ADDENDUM #2

Will County Health Department
BID PACKAGE #2 – Misc. Steel/Structural/Enclosure
November 5, 2018

RFI LOG
Will County Health Department
Bid Package #2

ROOF PLAN ①
SCALE: 1/16" = 1'-0"

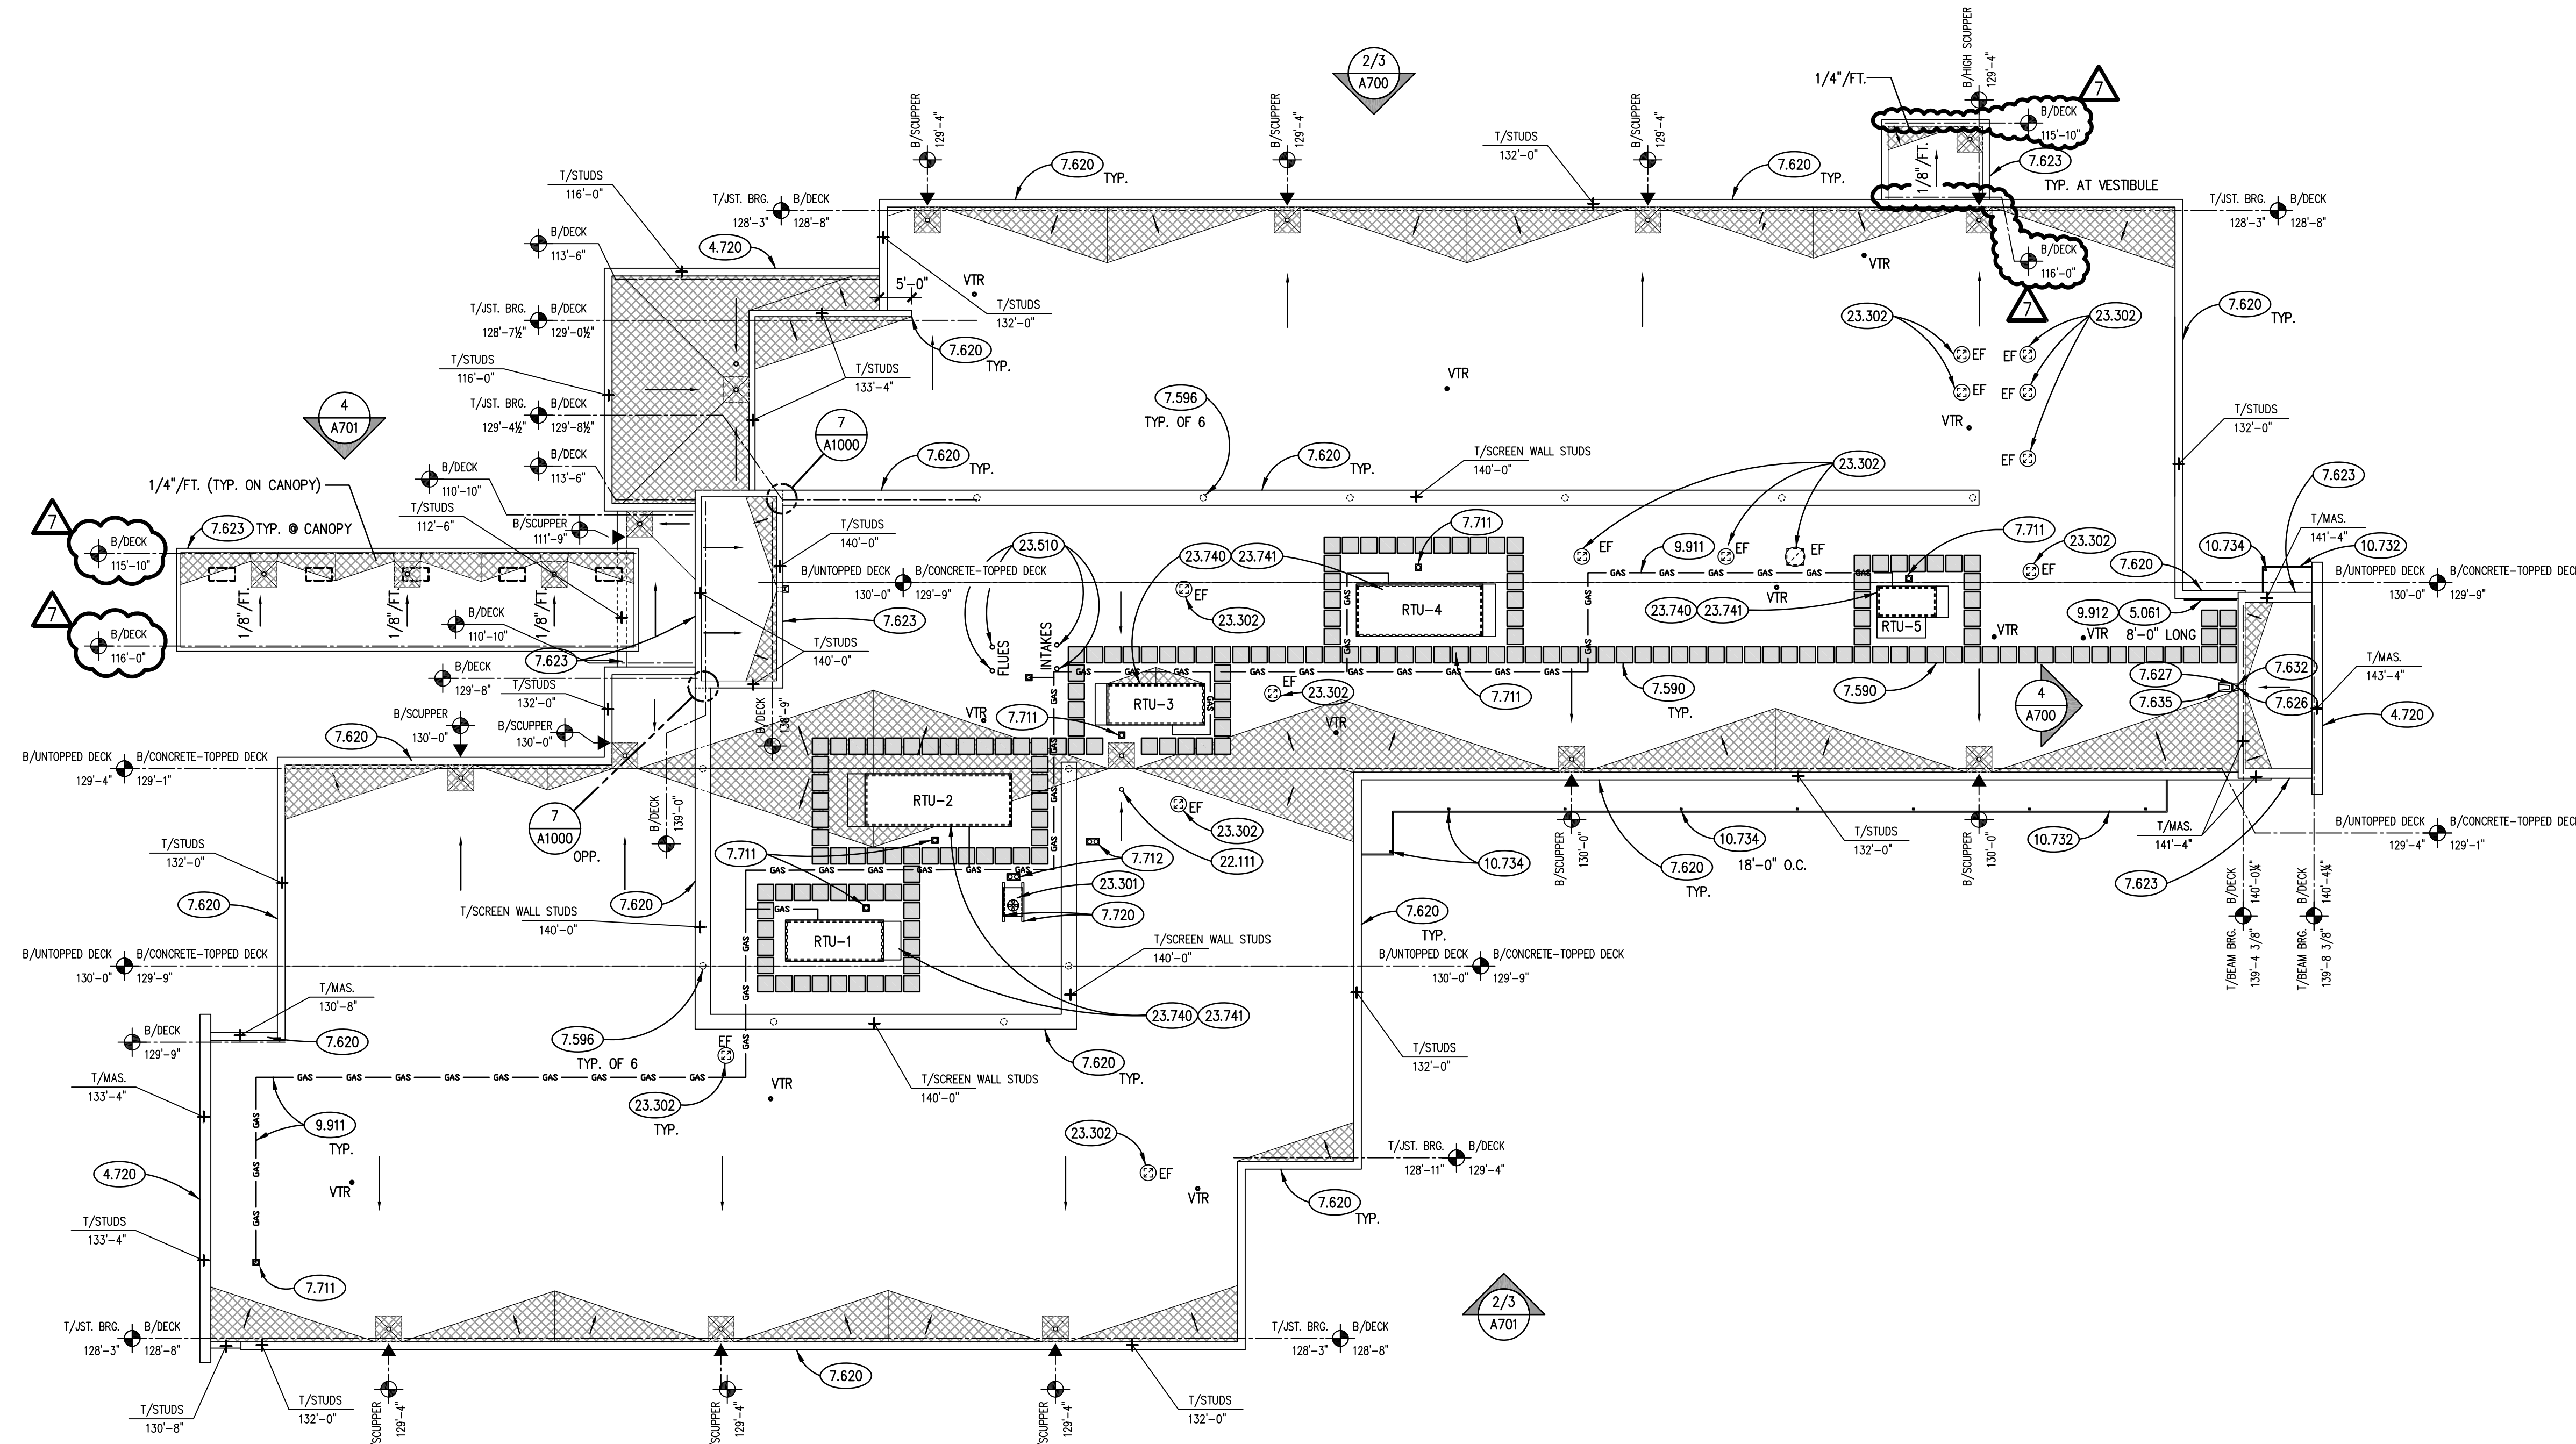
- A. Detail 1/A330: Revised the Bottom of Deck elevation tags of the west and northeast entrance canopies to coordinate with the building sections and structural details. See revision Cloud 7.

BUILDING SECTION 3
SCALE: 1/8" = 1'-0"

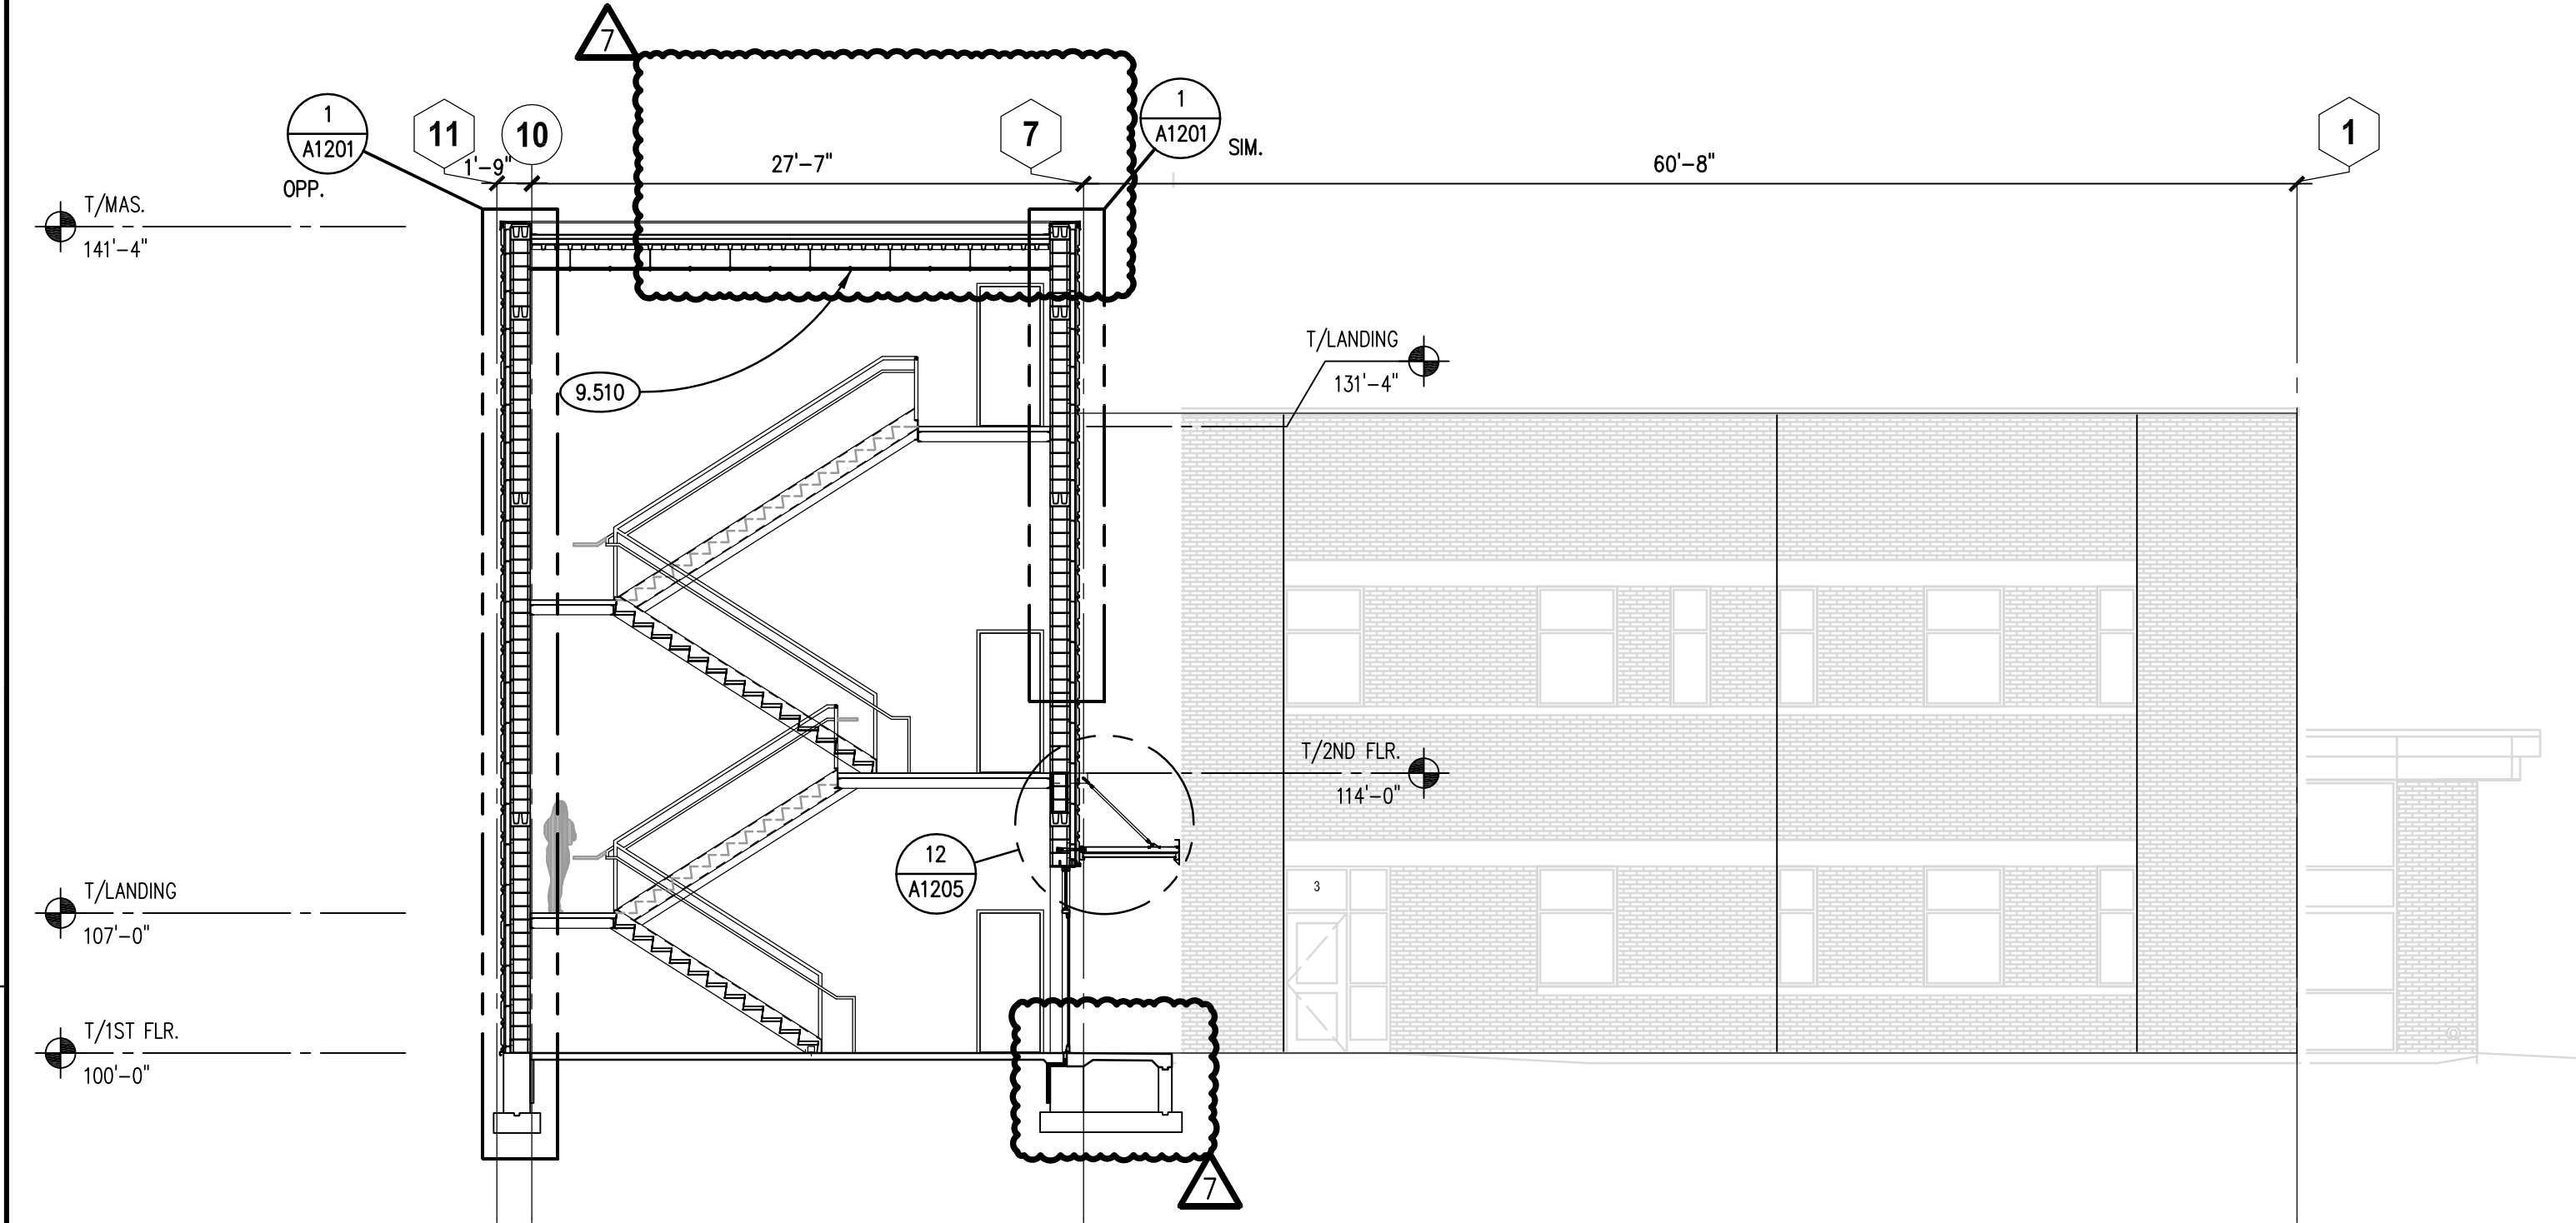
- A. Detail 3/A602: Updated Column Reference 7 location and added the exterior stoop graphic section.

SOUTH ELEVATION - EAST END
 SCALE: 1/8" = 1'-0"

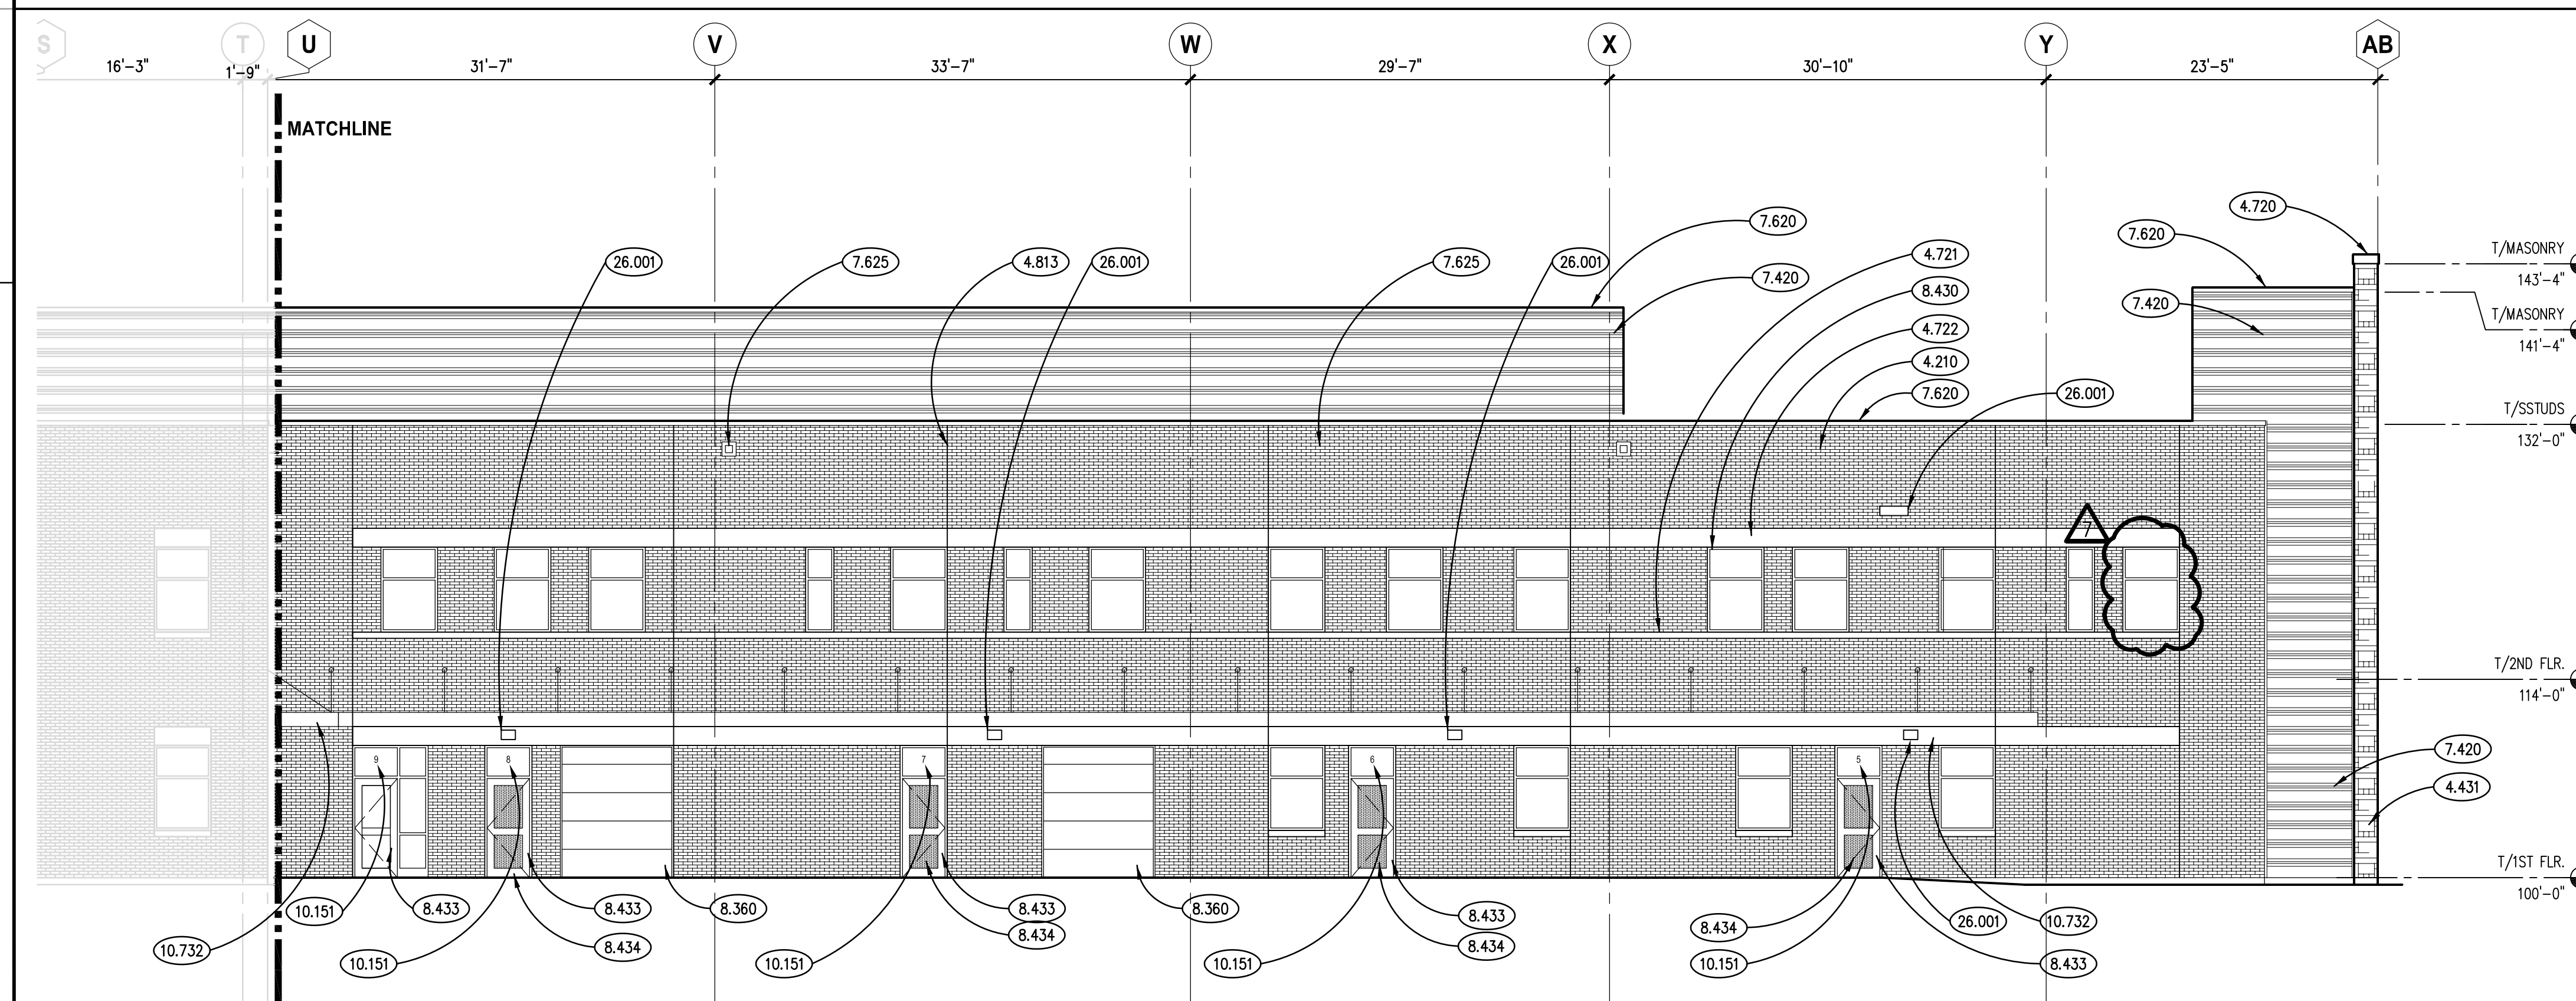
- A. Detail 2/A701 - South Elevation - East End: Removed the brick masonry hatching from the window right of column line Y as clouded.
